**REGULAR MEETING OF THE
CITY OF ALVARADO PLANNING AND ZONING COMMISSION
104 W. COLLEGE AVE.
MAY 16, 2024
6:30 PM
AGENDA**

This letter is to inform you that the attached Lone Oak Addition Phase 1 final plat application provided on April 22, 2024 has generated the recommendation of disapproval from the Alvarado Planning and Zoning Commission due to the following comments not being adequately addressed to result in compliance with the Alvarado subdivision ordinance.

ENGINEERING PLANS
FOR
LONE OAK PHASE 1
CITY OF ALVARADO
JOHNSON COUNTY, TEXAS
MARCH 2024

City Engineer Remarks on Preliminary Plat and Preliminary Engineering

LINE A2 STA. 6+00 – END & LINE A3		PROJECT NO.
STORM SEWER PLAN & PROFILE		BBC010
LONE OAK, PHASE 1		SHEET NO.
City of Alvarado, Johnson County, Texas		5.03

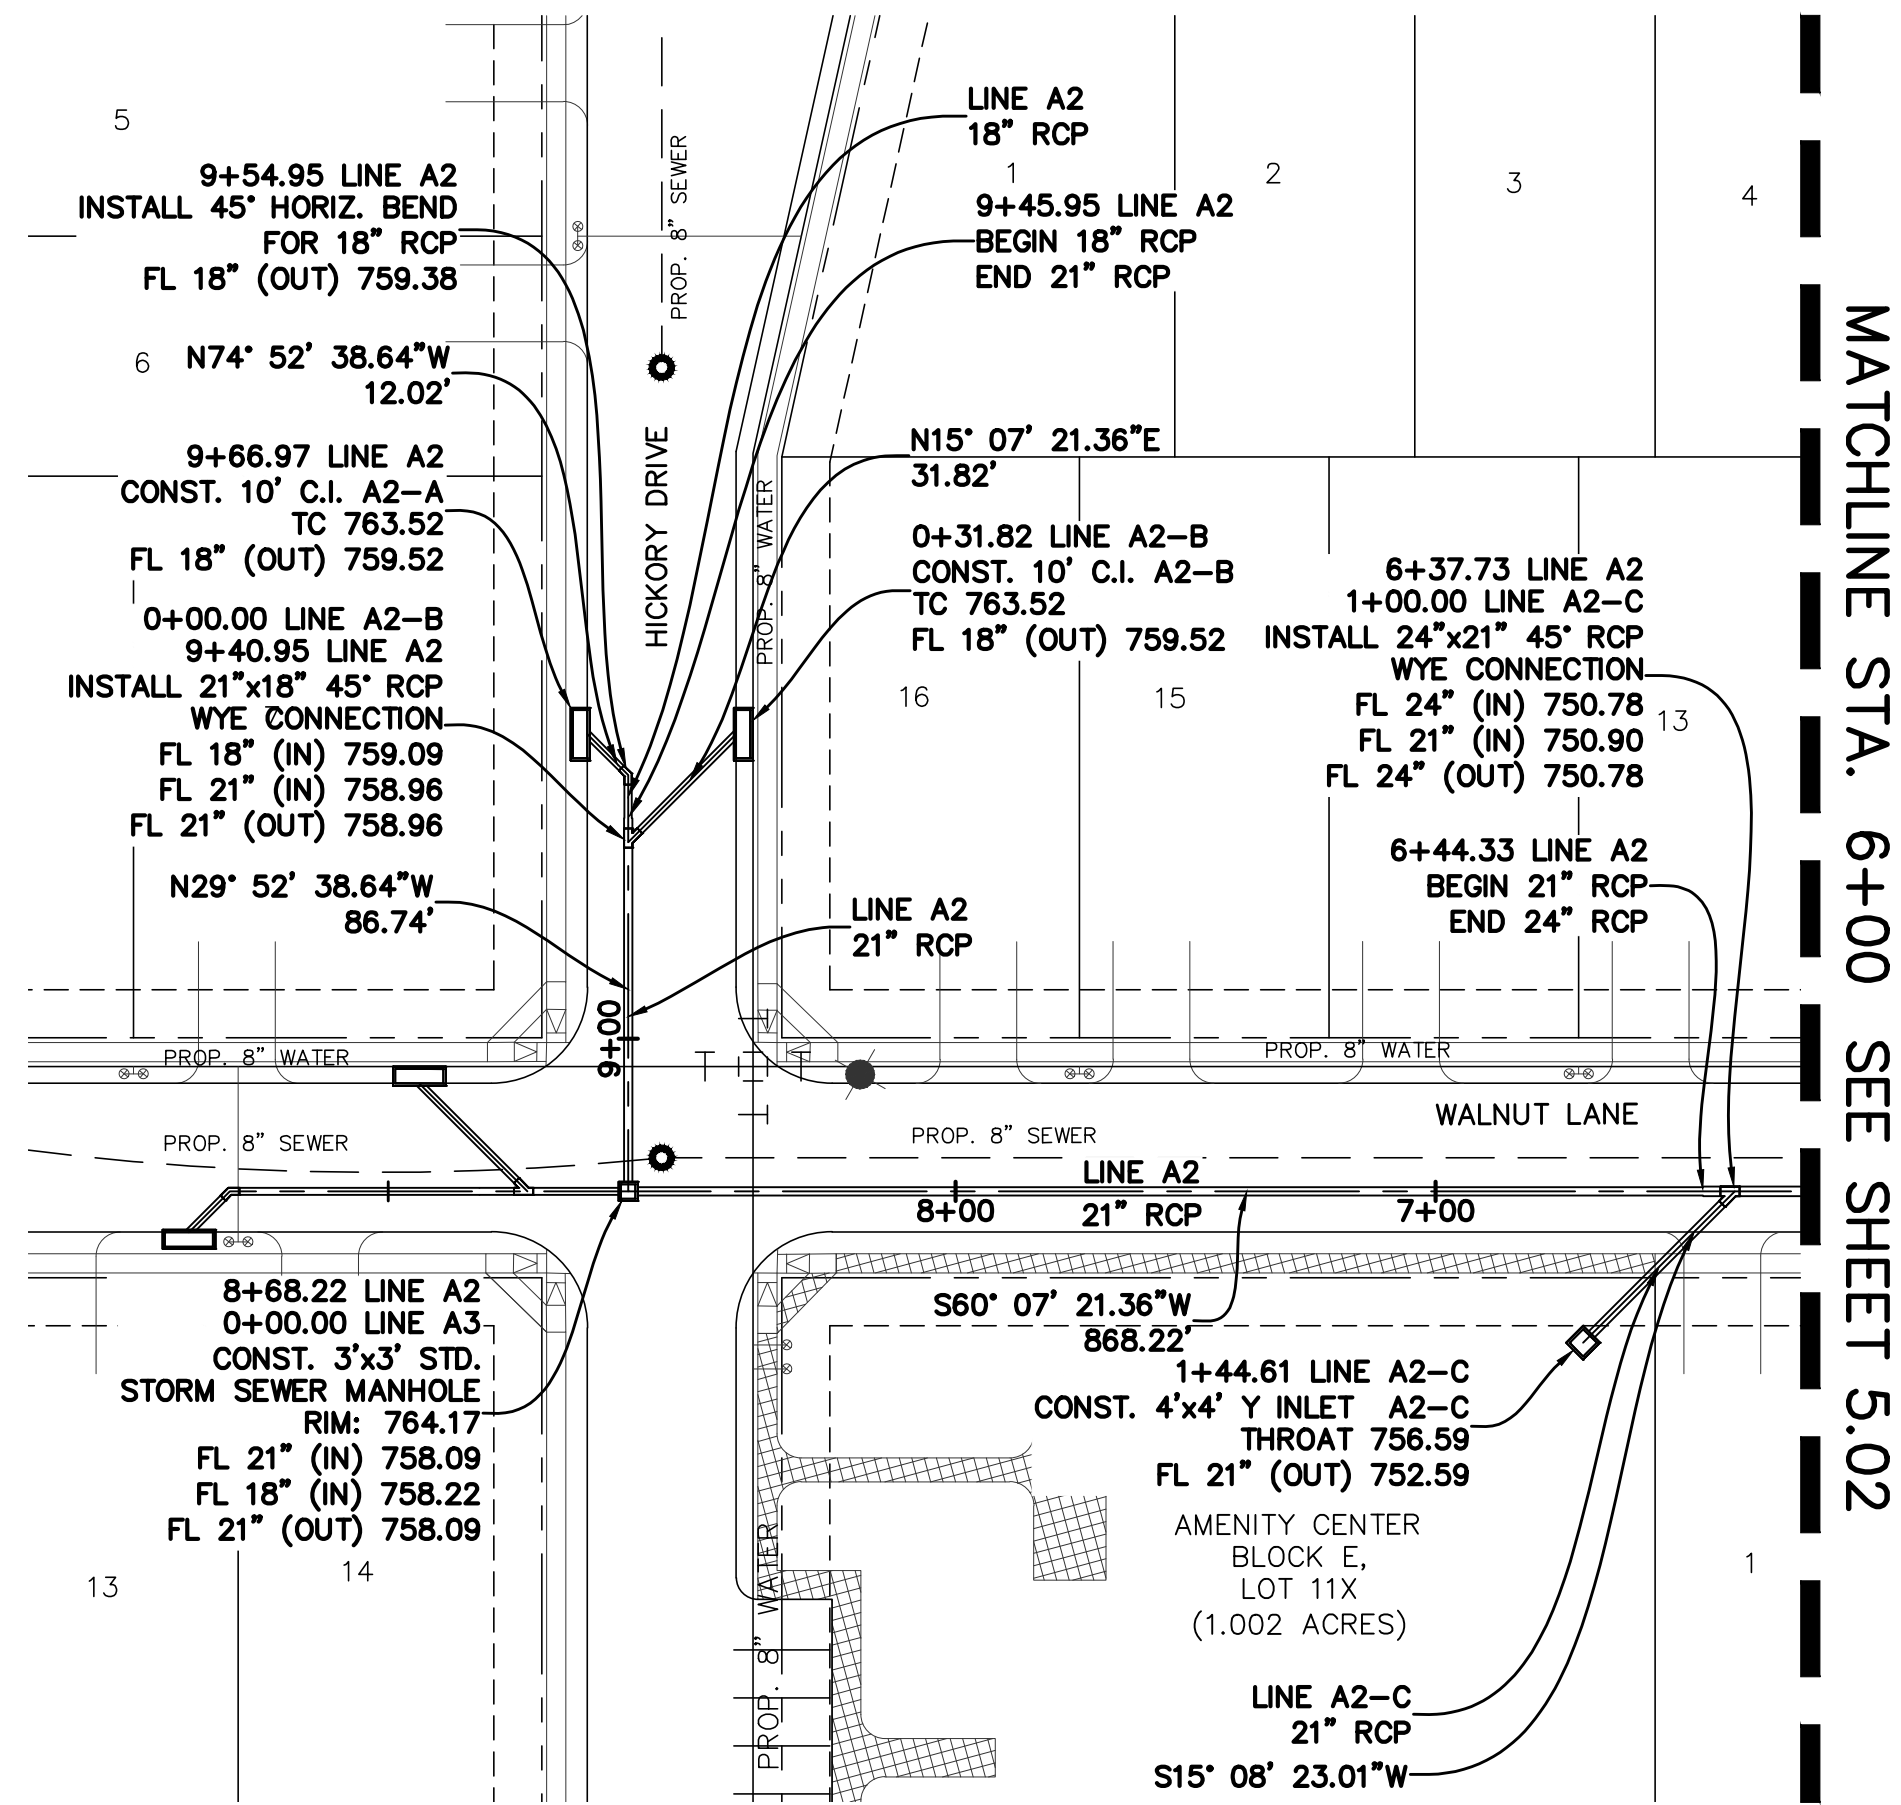
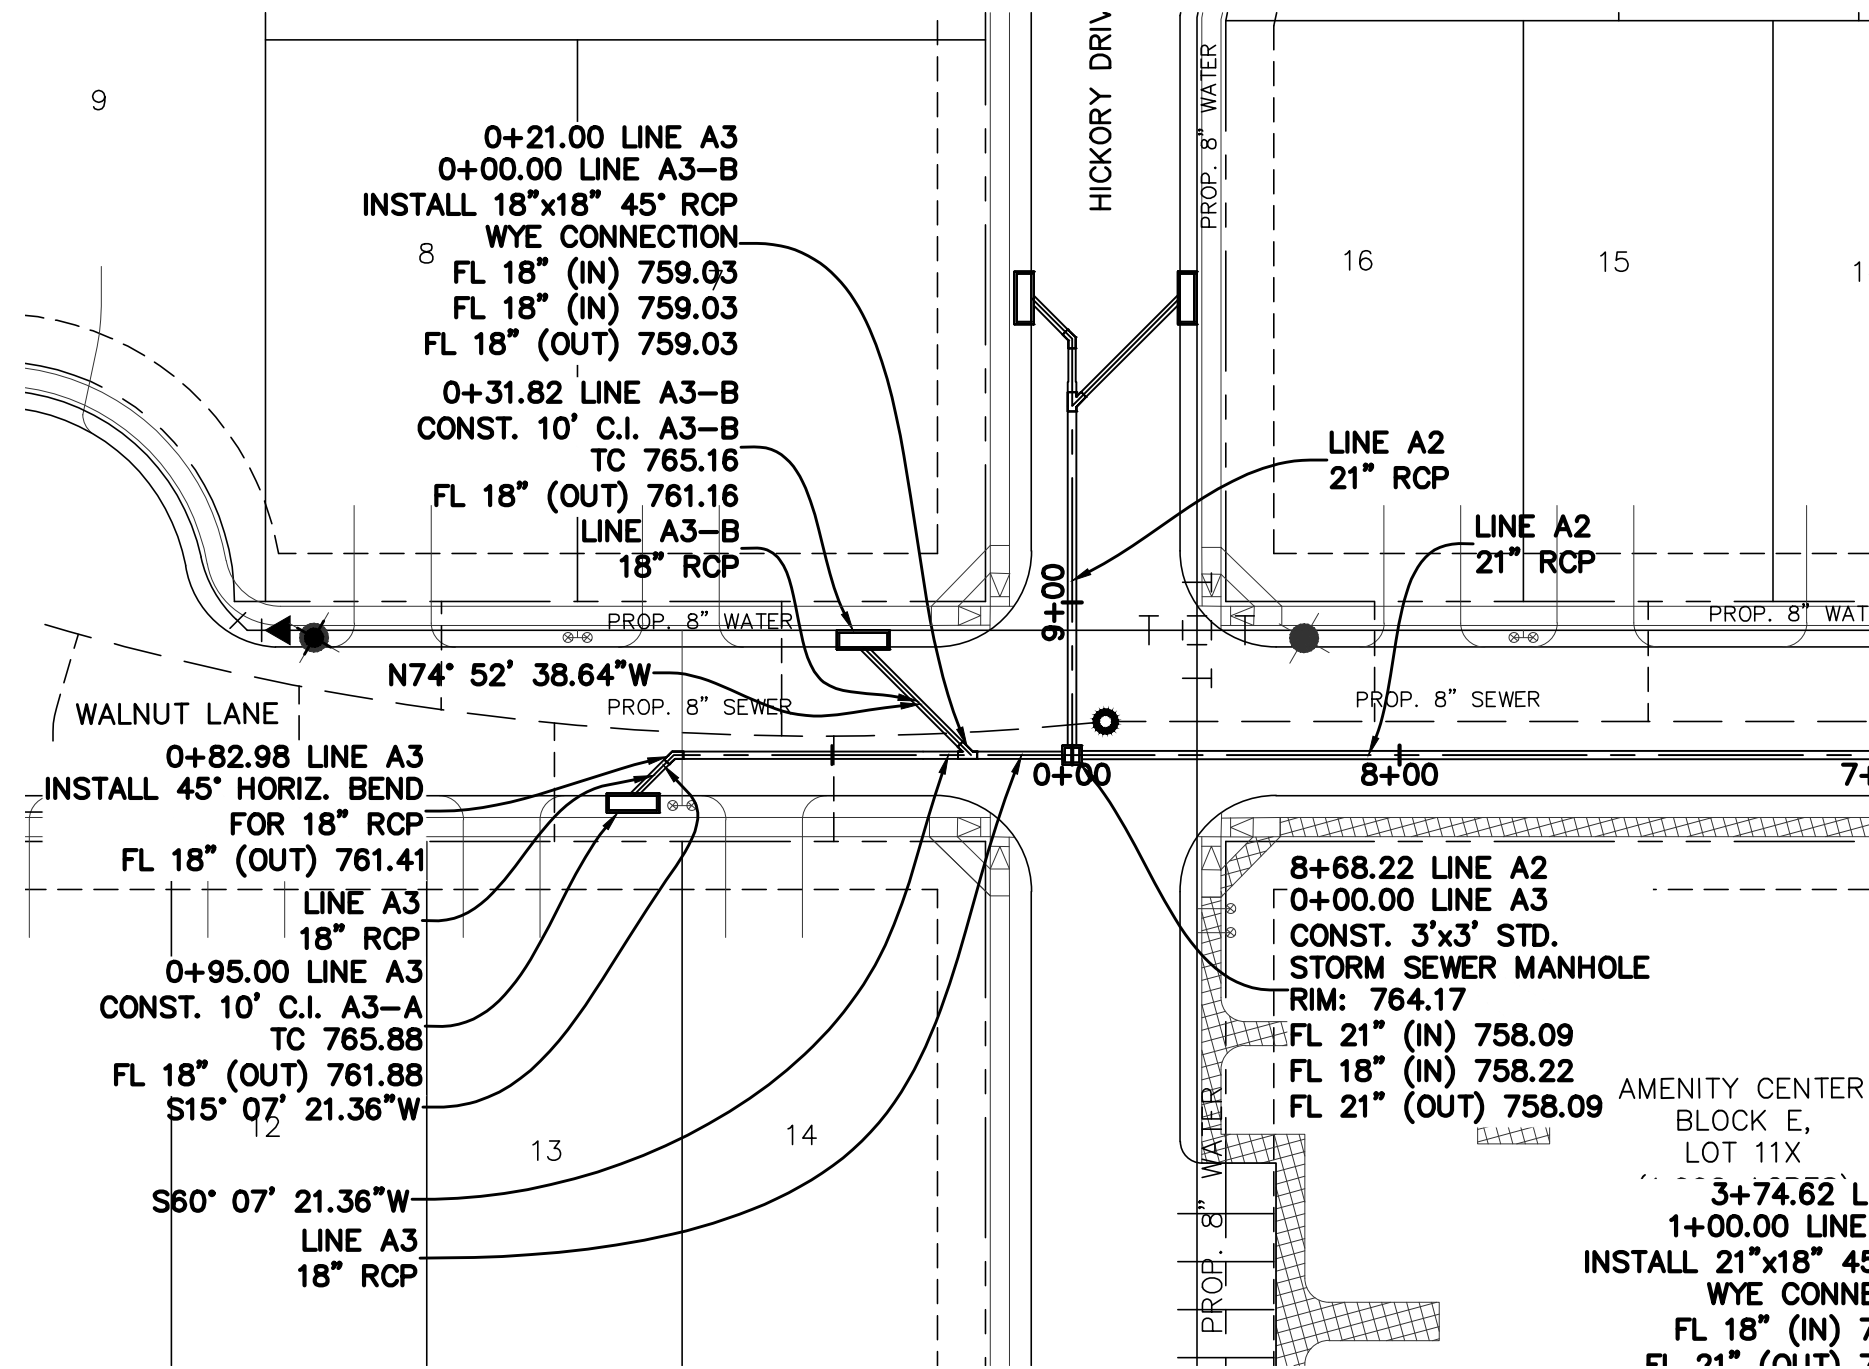
Recommend aerators in the retention pond
